ECN/PCN No.: M1206

Product Description: Axial Power Inductor	Abracon Part Number / Part Series: AIAP-02	☐ Documentation only ☒ ECN ☒ EOL	☒ Series ☐ Part Number(s)
Affected Revision: E	New Revision: F	Application:	☐ Safety ☒ Non-Safety

1.1 Test Conditions and equipments

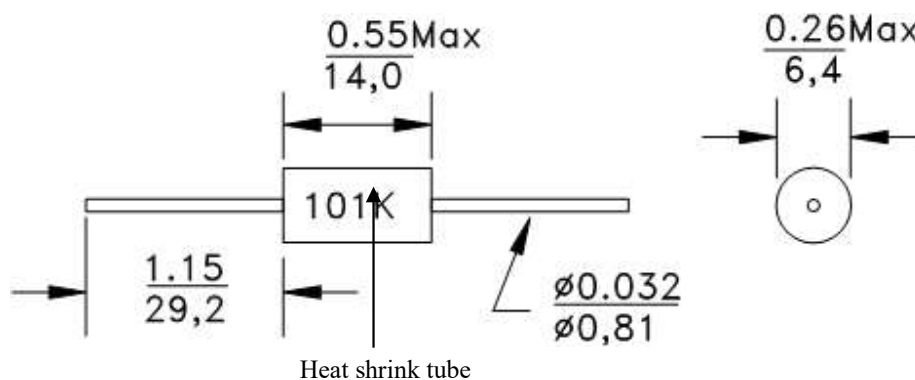
Test frequency: 1kHz, 0.1Vrms
I_{DC}: 10% inductance drops typical

Test frequency: 1kHz, 0.25V_{rms}

I_{DC}: 10% inductance drops typical

2.1 Test Conditions and equipments

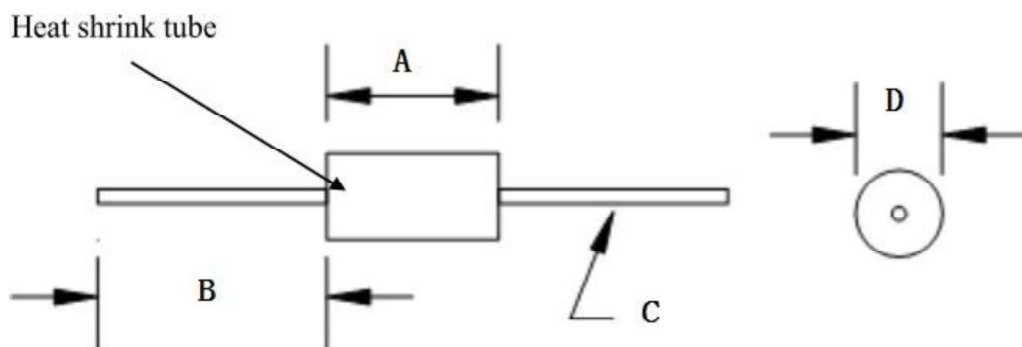
Cause/Reason for Change: Moving the series to a new production line,
Relaxed tolerance on some parts
AIAP-02-3R9
AIAP-02-4R7
AIAP-02-5R6
AIAP-02-6R8
change in operating temperature range, testing conditions, graphics, PCS/bag

-40°C ~ +125 °C (Including Self-heating)
